CITY OF ALBUQUERQUE

Planning Department

RE: **Lot 34 Block 6 Volcano Cliffs Unit 18 SAD 228**
6605 Sujeto NW
Grading and Drainage Plan
Engineers Stamp Date 7/19/19 (D10D003M34)
Pad Certification Date 7/30/19

ENGINEER'S SEAL 7/19/19 DAVID SOULE P.E. #14522	LOT 34 BK 6 U 18 VOLCANO CLIFFS SUB. 6605 SUJETO NW GRADING AND DRAINAGE PLAN 1608 CENTRAL AVENUE SE SUITE 201 ALBUQUERQUE, NM 87106 (505) 972-0899	DRAWN BY DEM DATE 7-19-19 LOT 34 BLK 6 UNIT 18 VOLCANO CLIFFS, DOW
		SHEET # C1 JOB #

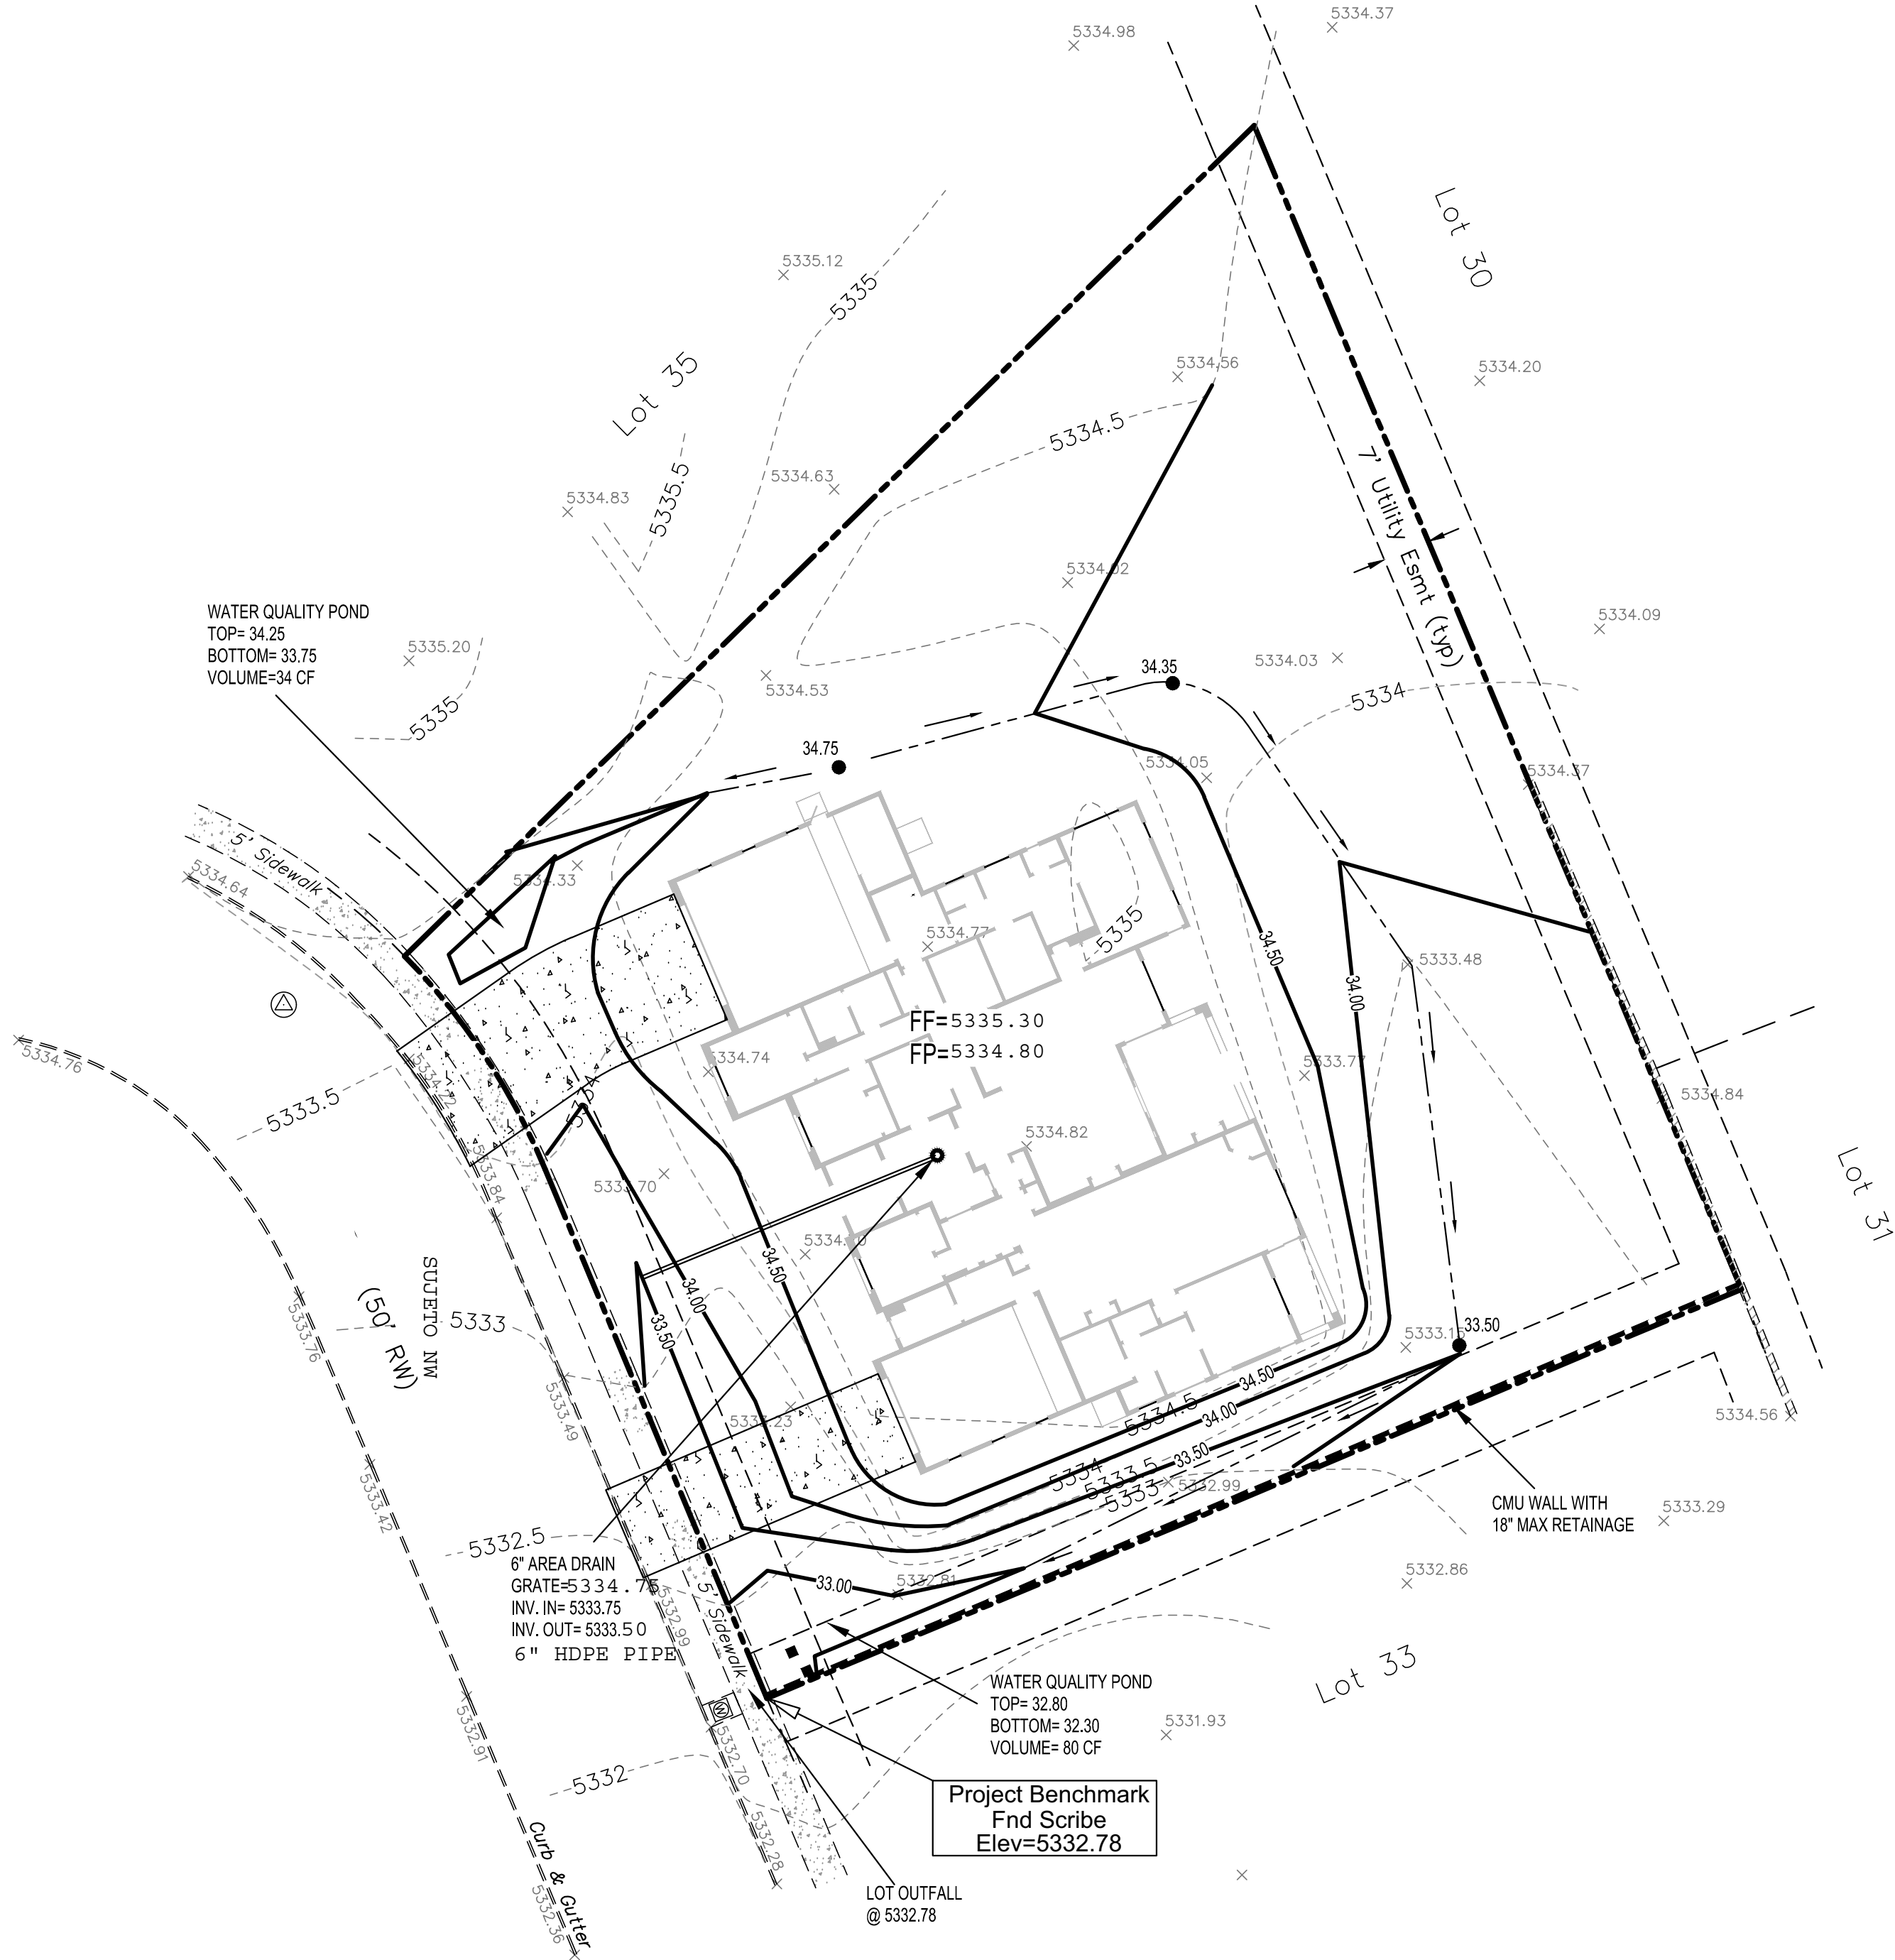
Based upon the information provided in your submittal received 7/31/19, this plan is approved for Building Permit.

Reiterate to the Owner/Contractor that a separate permit for a garden/retaining wall must be obtained, with the approved G&D plan dated 7/19/19 and Pad Certification Date 7/31/19.

Prior to Certificate of Occupancy release, Engineer Certification per the DPM checklist of this plan will be required.
